DEVELOPMENT ASSESSMENT REPORT –DA181/21. – SUBDIVISION 21 LOTS INTO 7909 Jenolan Caves Road GOOD FOREST NSW 2790

To assess DA181/21, with a recommendation for approval subject to conditions.

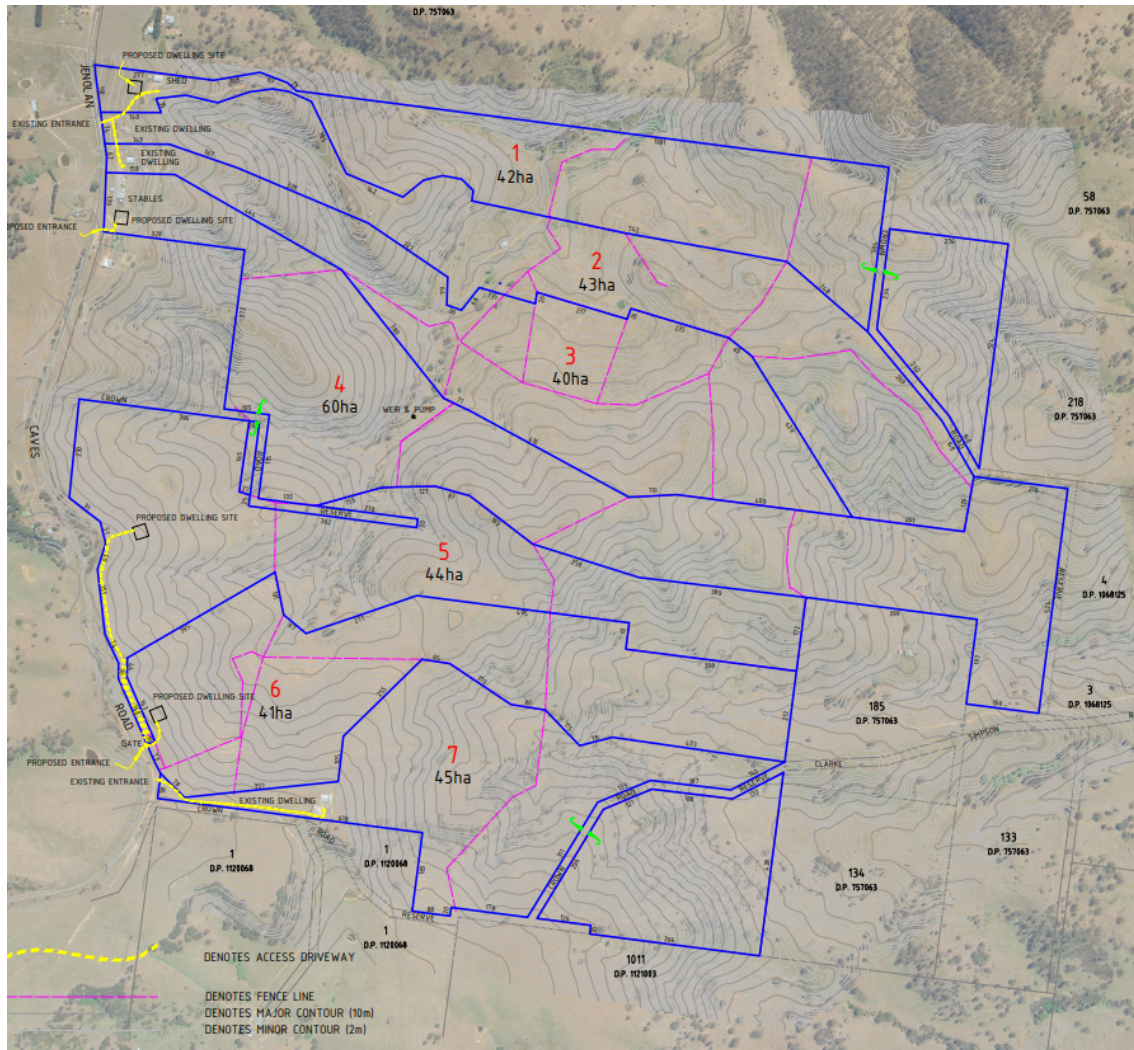
The configuration of the 7 new lots is illustrated in the plan extract below. The new lots will be configured as follows:

- Lot 1 – 42 hectares
- Lot 2 – 43 hectares (contains an existing dwelling)
- Lot 3 – 40 hectares (contains an existing dwelling)
- Lot 4 – 60 hectares (contains existing stables)
- Lot 5 – 44 hectares
- Lot 6 – 41 hectares
- Lot 7 – 45 hectares (contains an existing dwelling)

Riparian Land and Watercourses

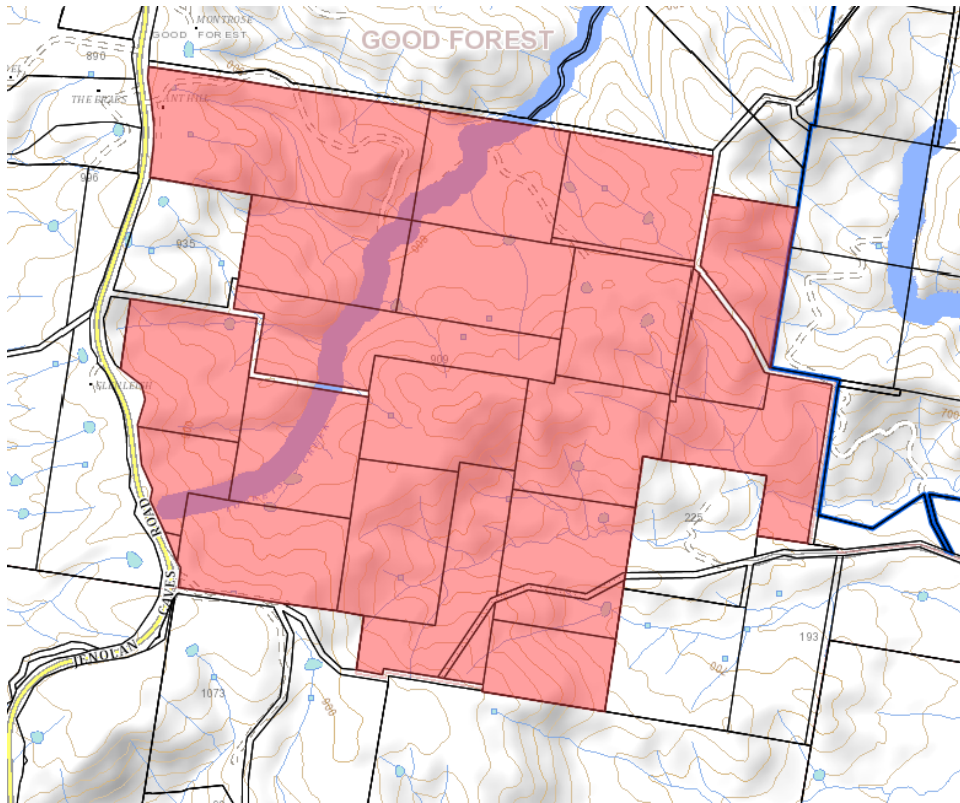
Clause 7.6 of the LLEP requires the consideration of impacts on the water quality of watercourses and related ecologies. The subject land is bisected by Yorkeys Creek which is identified on the Environmentally Sensitive Areas – Water Overlay Map (see extract below). The subdivision proposal will not directly impact on the identified riparian areas of the site. The proposed lots have sufficient areas not constrained by biodiversity to enable use for rural land uses and future dwellings (which will be subject to separate assessment and development consent).
